CUC-RFP-25-021

Independent Power Producer-Solar Photovoltaic with Battery Energy Storage System (BESS)
for all Islands, CNMI

Question (RFI/C) No. 012: IP&E SOLAR

Date: September 25, 2025

SAIPAN SINGLE LINE DIAGRAM

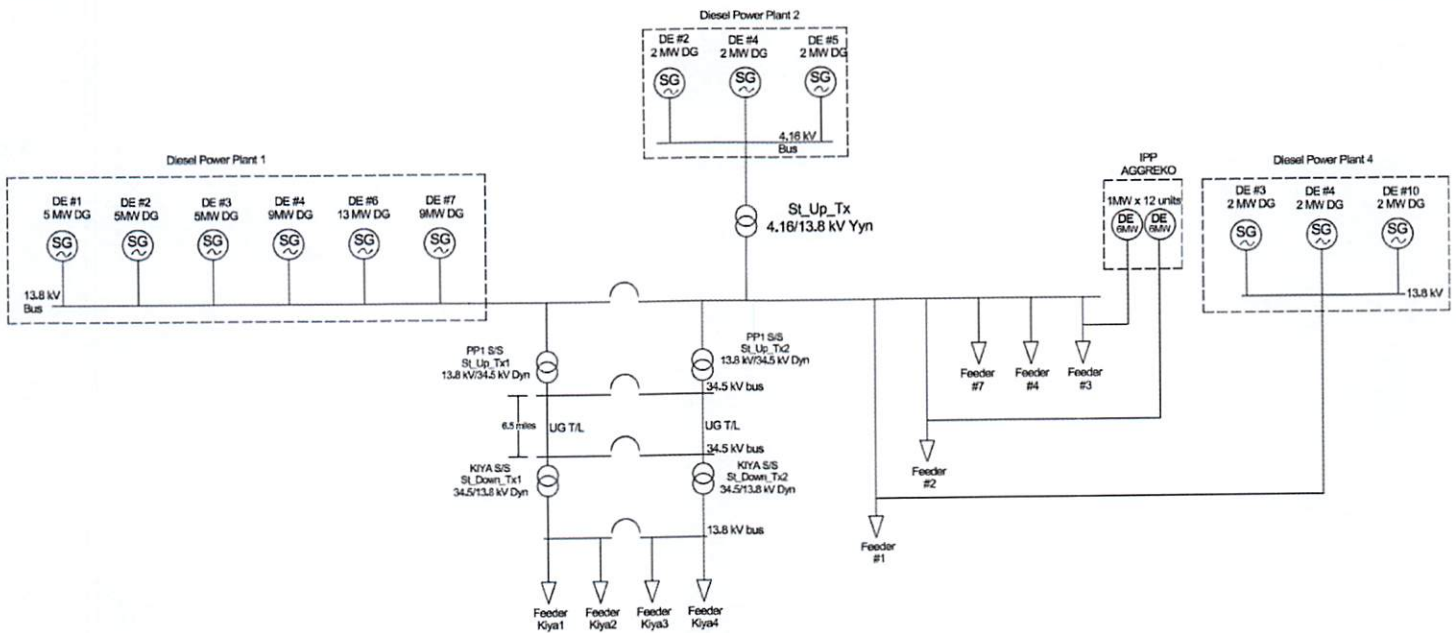
10. What is the generator make up of each powerplant on each island? How many generators by location and what is their generating capacity? Please share single-line diagram up to and including interconnection point (reference: Table 1.7.1).

CUC RESPONSE:

SAIPAN POWER PLANTS

A. PP1

GENERATOR NO.	COMMISSIONING DATE	RATING (MW)	STATUS
DE1	Mar-80	7.2	OPERATIONAL
DE2	Mar-80	7.2	OPERATIONAL
DE3	Mar-83	7.2	OPERATIONAL
DE4	25-Apr	8.7	OPERATIONAL
DE5	Apr-90	13	DECOMMISSIONED
DE6	May-90	13	FOR FOUNDATION REPAIR
DE7	Mar-92	13	OPERATIONAL
DE8	Mar-92	13	DECOMMISSIONED

B. PP2

DE1	1986	2.5	DECOMMISSIONED
DE2	1986	2.5	OPERATIONAL
DE3	1986	2.5	DECOMMISSIONED
DE4	1986	2.5	OPERATIONAL
DE5	1986	2.5	OPERATIONAL
DE6	1986	2.5	DECOMMISSIONED

C. PP4

DE2	1968	2.1	UNDER MAINTENANCE
DE3	1968	2.1	OPERATIONAL
DE4	1992	2.5	OPERATIONAL
DE5	1992	2.5	UNDER MAINTENANCE
DE10	2005	2.5	OPERATIONAL
